2023 年 12 月 8 日 按照城市規劃條例第 5 條展示的
核准圖編號 S/K14S/URA1/2 的修訂
AMENDMENTS TO APPROVED PLAN No. S/K14S/URA1/2 EXHIBITED
UNDER SECTION 5 OF THE TOWN PLANNING ORDINANCE ON
8 DECEMBER 2023

香港城市規劃委員會依據城市規劃條例擬備的市區重建局觀塘市中心 - 主地盤發展計劃圖
TOWN PLANNING ORDINANCE, HONG KONG TOWN PLANNING BOARD
URBAN RENEWAL AUTHORITY KWUN TONG TOWN CENTRE
DEVELOPMENT SCHEME PLAN - MAIN SITE

圖則編號
PLAN No. S/K14S/URA1/3

**SCHEDULE OF AMENDMENTS TO
THE URBAN RENEWAL AUTHORITY KWUN TONG TOWN CENTRE -
MAIN SITE DEVELOPMENT SCHEME PLAN NO. S/K14S/URA1/2
MADE BY THE TOWN PLANNING BOARD
UNDER THE TOWN PLANNING ORDINANCE (Chapter 131)**

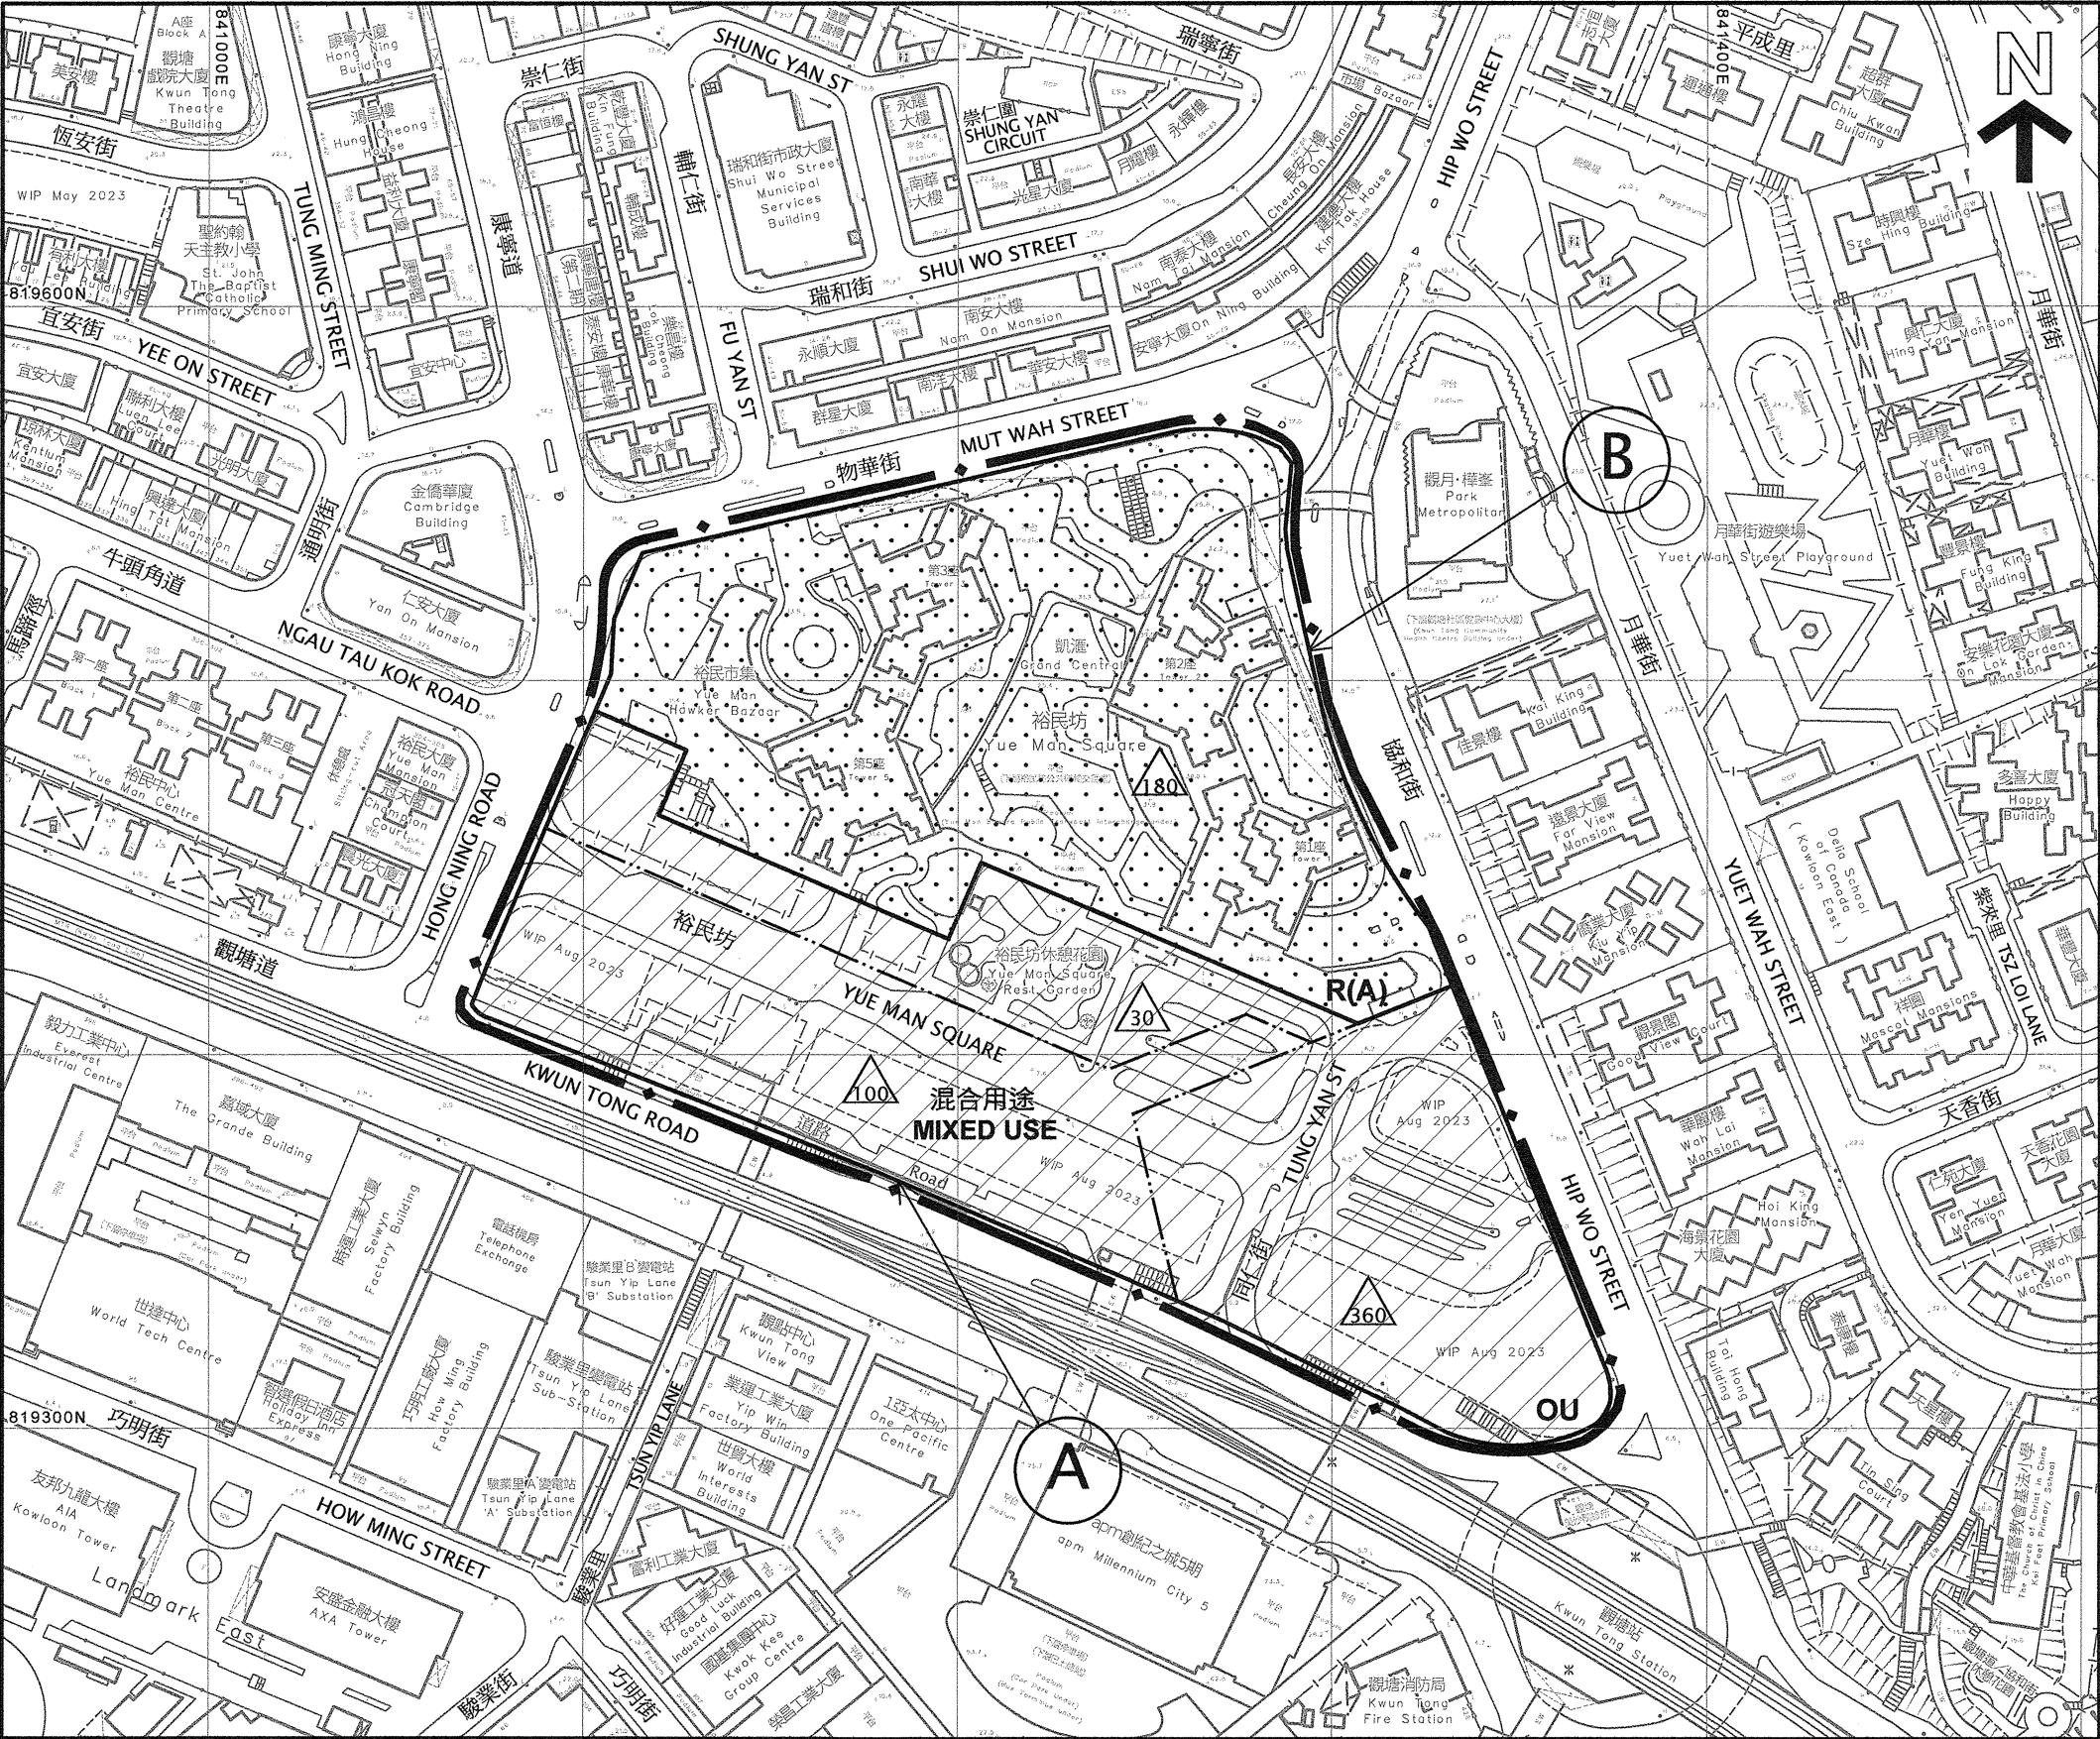
ITEM A | 由「綜合發展區 (1)」地帶改劃作「其他指定用途」註明「混合用途」地帶
REZONING FROM "COMPREHENSIVE DEVELOPMENT AREA(1)"
TO "OTHER SPECIFIED USES" ANNOTATED "MIXED USE" |

ITEM B | 由「綜合發展區 (1)」地帶改劃作「住宅 (甲類)」地帶
REZONING FROM "COMPREHENSIVE DEVELOPMENT AREA(1)"
TO "RESIDENTIAL (GROUP A)" |

- Item A – Rezoning of a site to the north of Kwun Tong Road from “Comprehensive Development Area (1)” (“CDA(1)”) to “Other Specified Uses” annotated “Mixed Use” (“OU(MU)”) with stipulation of building height (BH) restrictions.
- Item B – Rezoning of a site to the south of Mut Wah Street from “CDA(1)” to “Residential (Group A)” (“R(A)”) with stipulation of BH restriction.
